APPLICATION FOR A CERTIFICATE OF APPROPRIATENESS – STAFF REPORT

059-18-CA 814 OBERLIN ROAD
Applicant: PRESERVATION NORTH CAROLINA
Received: 4/12/2018 Meeting Date(s):
Submission date + 90 days: 7/11/2018 1) 5/24/2018 2) 3)

Nature of Project: Landscape master plan; install 12' sculpture; remove non-historic chimney (Hall House); remove non-historic windows and replace (Hall House)

814 Oberlin Rd - New Front Elevation

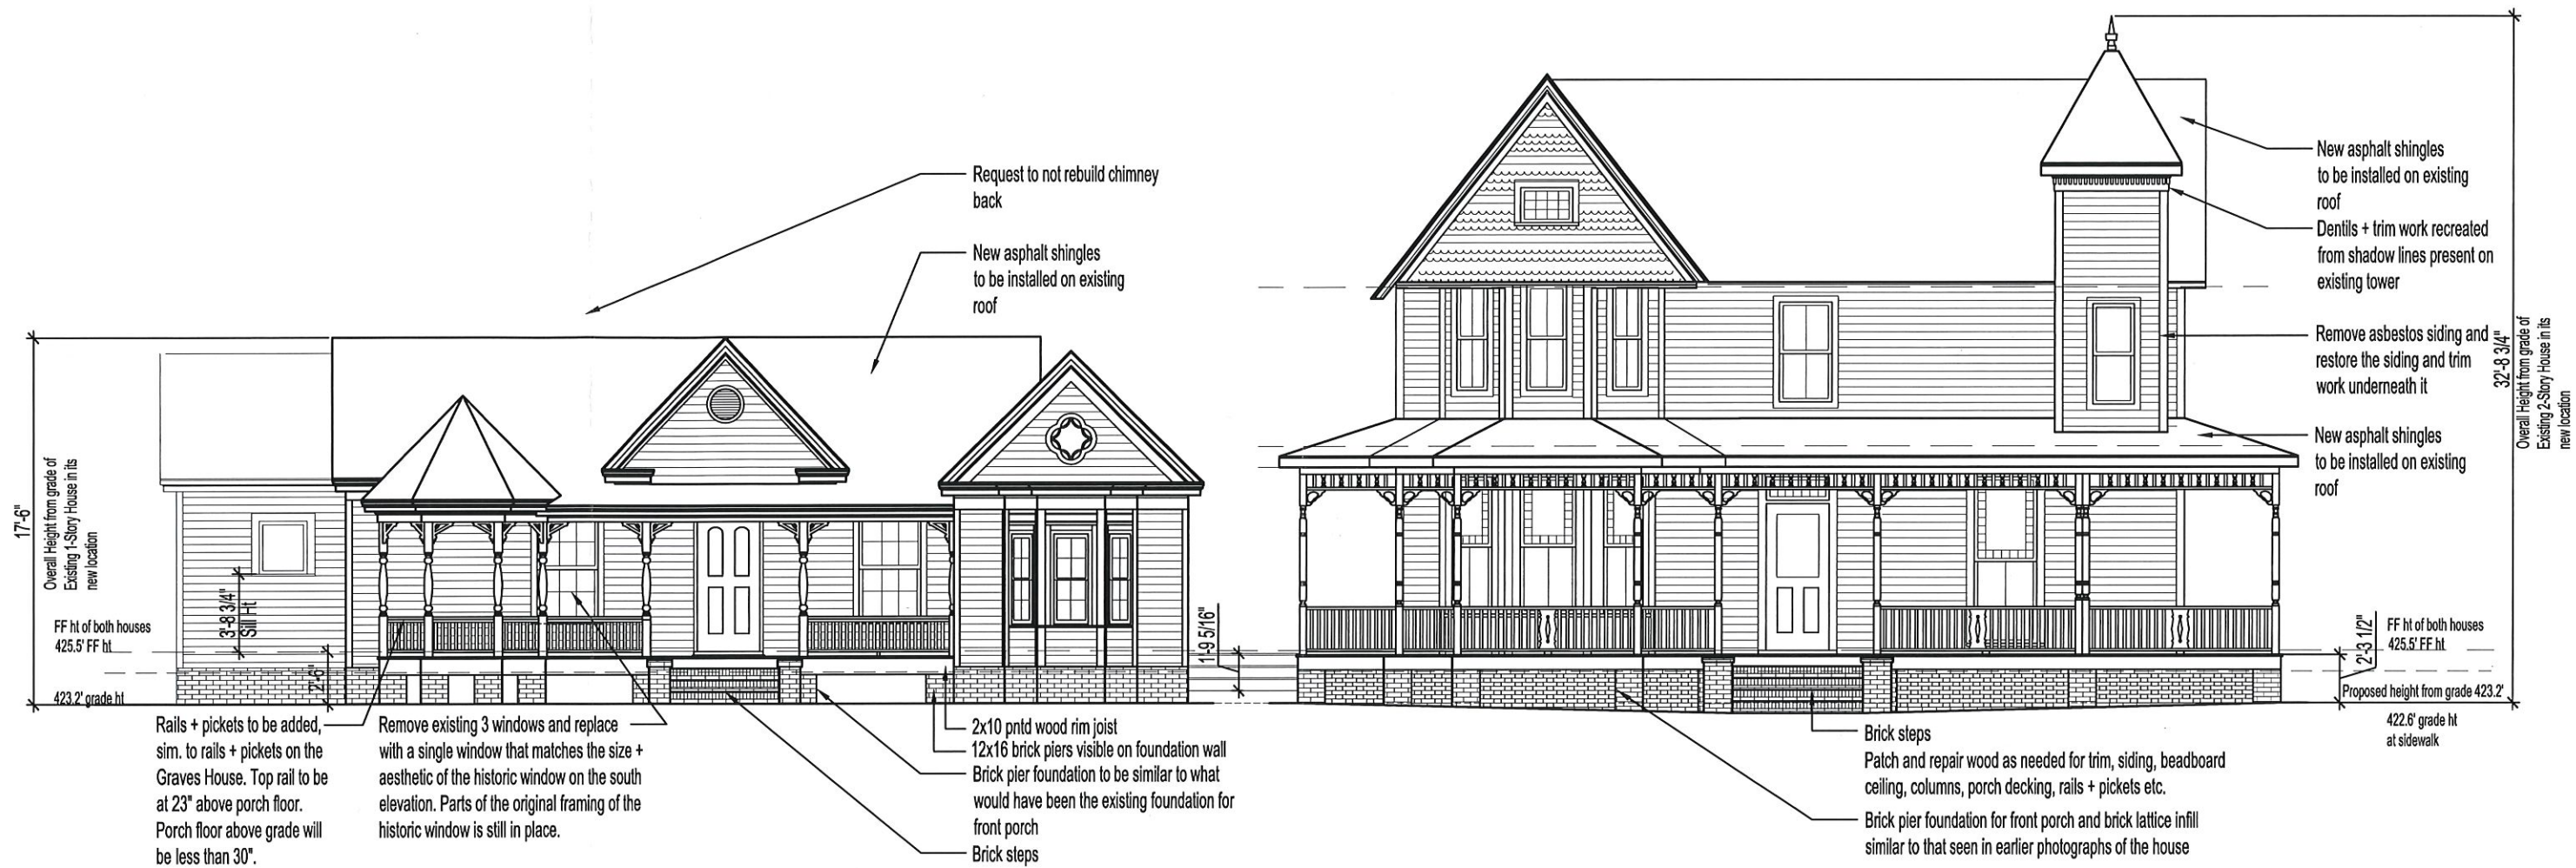
New brick foundation to support new wood framing + floor of porch.
 Request removing center window (newer wdw of the three we believe) and replace with a 6/6 double hung window to match the existing on the front elevation

814 Oberlin Rd - New Front Elevation

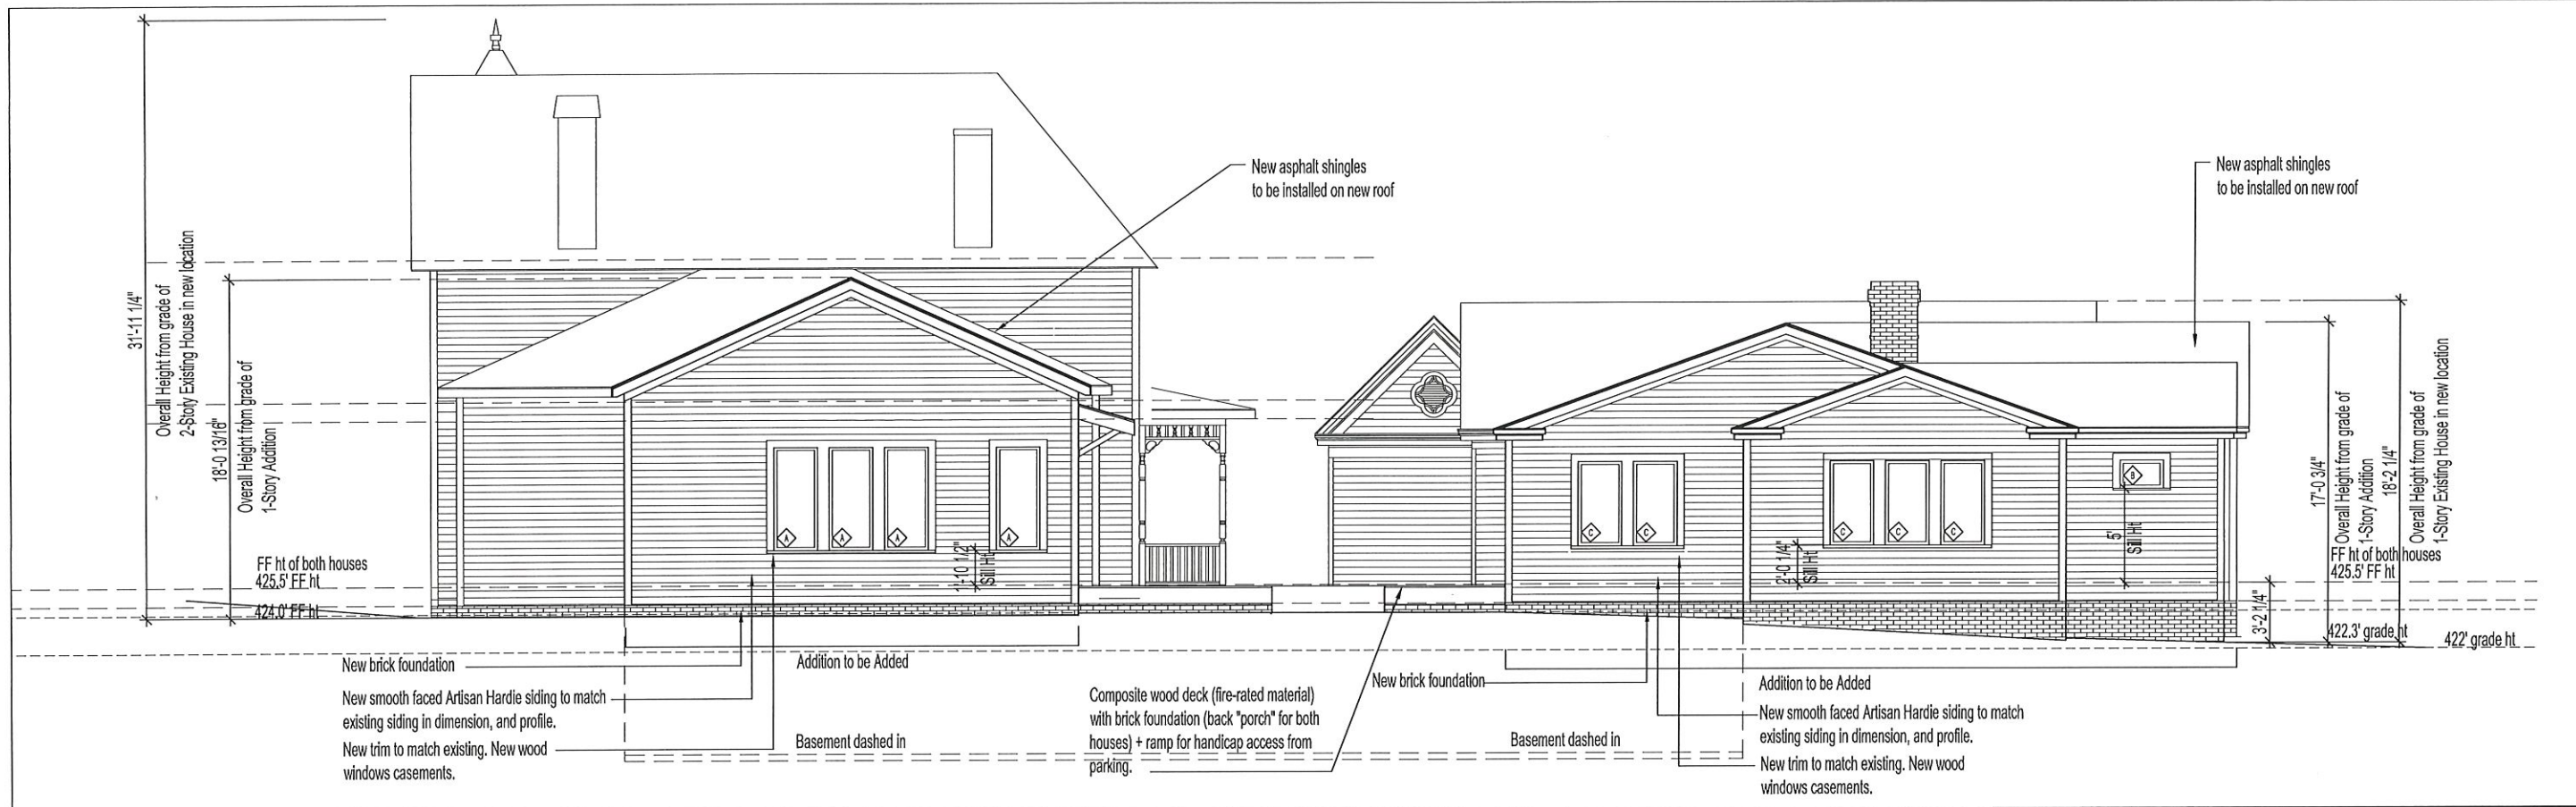
Request removal of aluminum siding and restore the siding and trim work underneath it

.Past photo showing the original single window on the Hall House with shutters

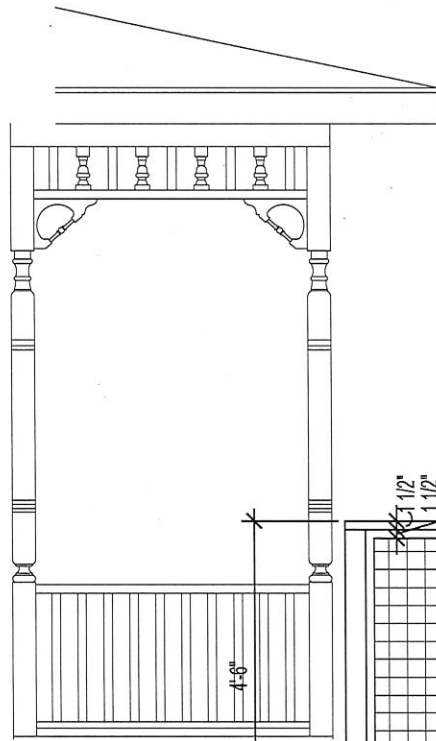
- 1* The applicant proposes removing three ganged windows on the front porch and replacing with a single wood 6/6 double hung window. Evidence was provided for this configuration with a historic photo. In addition, the applicant states that parts of the original framing are in place.
- 2* Two other windows are proposed to be removed and replaced, one on the north side of the building and one on the right side of the front door. The applicant states the existing windows are “modern, cheap and smaller than the one surviving original window.” No evidence was provided by the applicant. The replacement windows will be wood 6/6 double hung windows to match the historic window on the south elevation.
- 3* Window specifications were included in the application.
- 4*

Wood Carmel Double Hung

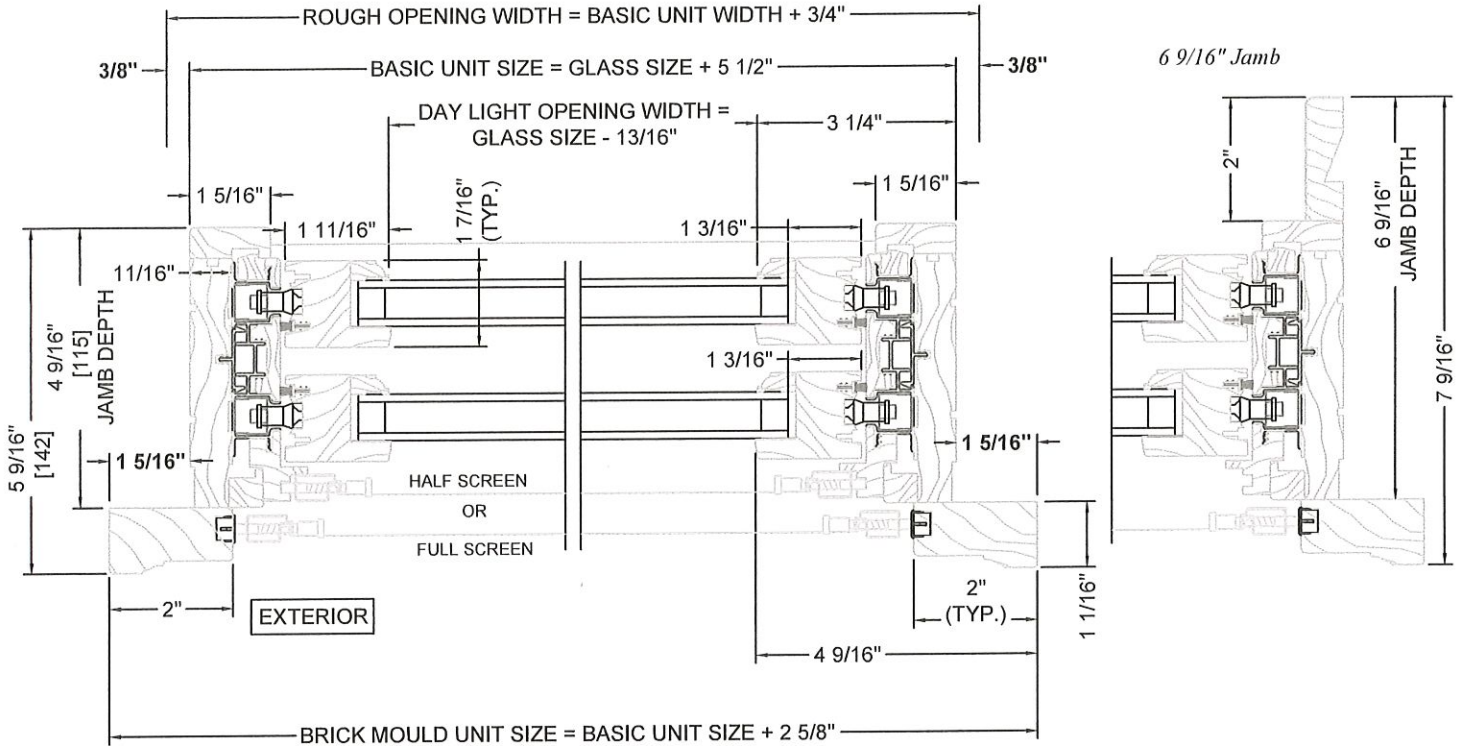
all requested windows to be changed in this application will be this size which is the closest to the historic window on the South Elevation of the Hall House
